# HYUNDAI Technical Service Bulletin

Group CLIMATE CONTROL
Number 06-97-001
Date APRIL, 2006
Model 2006 AZERA, SONATA

Subject  
**2006 AZERA / SONATA AMBIENT TEMPERATURE SENSOR REPLACEMENT**

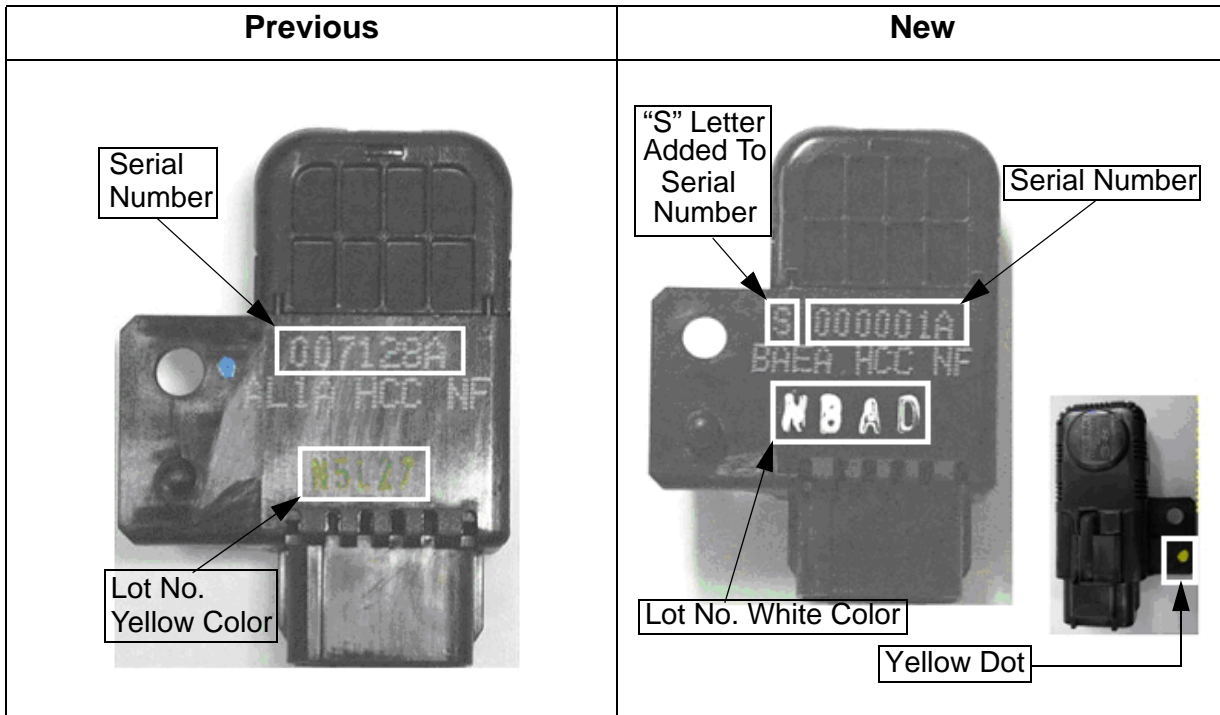
On some vehicles the ambient temperature displayed on the climate controller may differ from the actual outside temperature by more than 5-10°F. An updated ambient temperature sensor is available to improve this condition. This TSB provides the procedure to install the updated ambient temperature sensor located in front of the radiator/condenser.

- To determine if the vehicle has a factory installed or an updated part refer to the photos below.

- The current part number will continue to be used with the updated part.
